MARK	DATE	DESCRIPTIONS	BY	CH'D	CCO#
0	03/08/10	MEP INTEGRATION	SYC	FW	110

CONTRACT CHANGE ORDER NO._____
SHEET _____ OF _____

DETAILS
BRIDGE STRUCTURES GIRDER WESTBOUND MAIN BRIDGE SYSTEM GROUNDING-WB
SCALE: 1:3000

E-666

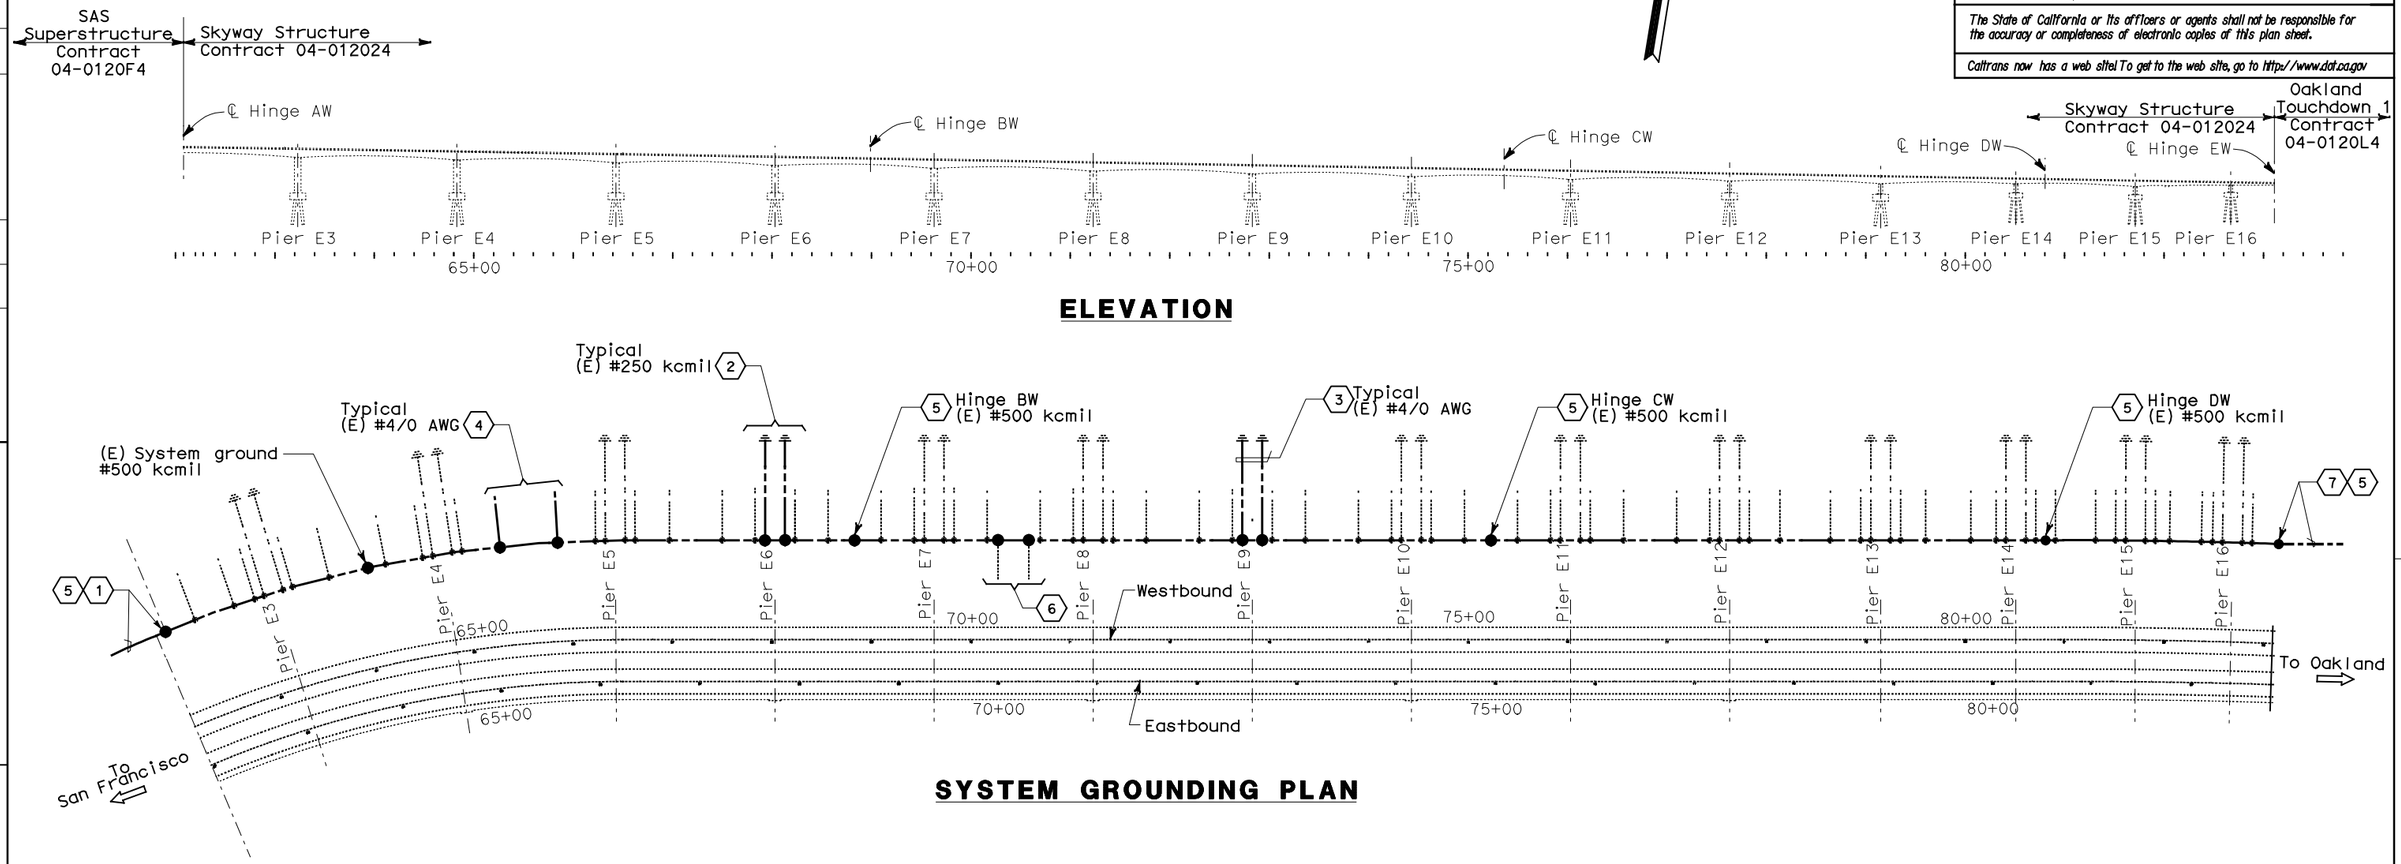
(1) The Contractor shall connect the system ground provided by Skyway contract. The system ground #500 kcmil shall be exothermically connected from SAS contract.

(2) The Contractor shall visually inspect the ground connection to the pier column. The ground connection is #250 kcmil to the system ground.

(3) The Contractor shall visually inspect the ground connection to the service platform. The ground connection is #4/0 AWG, routed inside an existing conduit to the system ground.

(4) The Contractor shall visually inspect the ground connection the cable tray racks. The ground connection is #4/0 AWG, located 1/3 the distance between pier columns.

(5) The Contractor shall disconnect and remove the connected system ground routed inside the existing hinge conduits. This ground conductor shall be re-installed together with 15 kV feeder cable. The ground conductors shall be exothermically re-connected.

(6) The Contractor shall visually inspect the ground connections to the ground bar inside the substation. The bar is connected to the system ground.

(7) The Contractor shall connect the system ground provided by Oakland Touchdown OTD-1 contract. The system ground #500 kcmil provided by Skyway contract shall be exothermically connected by this Contractor.
